Historic Preservation Commission

IV. Case A24-0660 SPA Properties - COA

HORTON HOTEL II • project
587 W. KING ST • location
BOONE, NC 28607
HPC-01 HORTON HOTEL II • plan
INFORMATION
02/05/2024 • date

Case A24-0660 SPA Properties - Certificate of Appropriateness for Major Work

2 KING STREET ELEVATION HPC
HPC-02 1/8" = 1'-0"

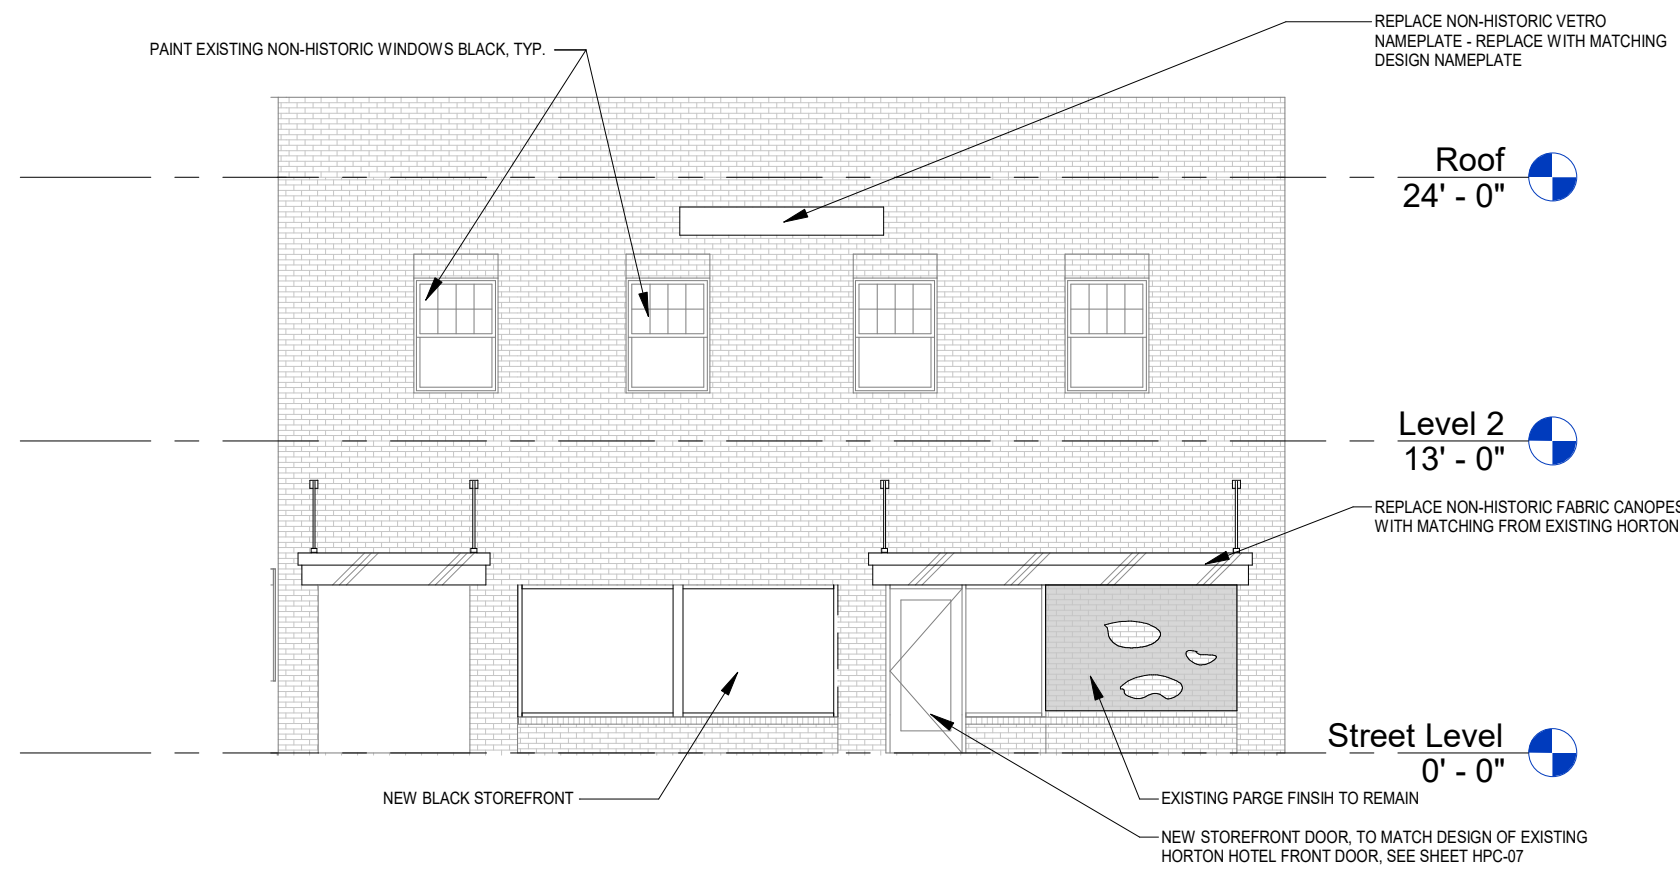
-REPLACEMENT OF EXISTING STORFRONT GLAZING WITH NON REFLECTIVE IGU'S (INSULATED GLASS UNITS) (CODE SECTION 6.5)
-AWNING DESIGN TO BE SIMILAR TO EXISTING HORTON HOTEL (CODE SECTION 6.12)
- NON HISTORIC OPENINGS AND WINDOWS ALREADY EXISTING (CODE SETION 6.1, 6.2)
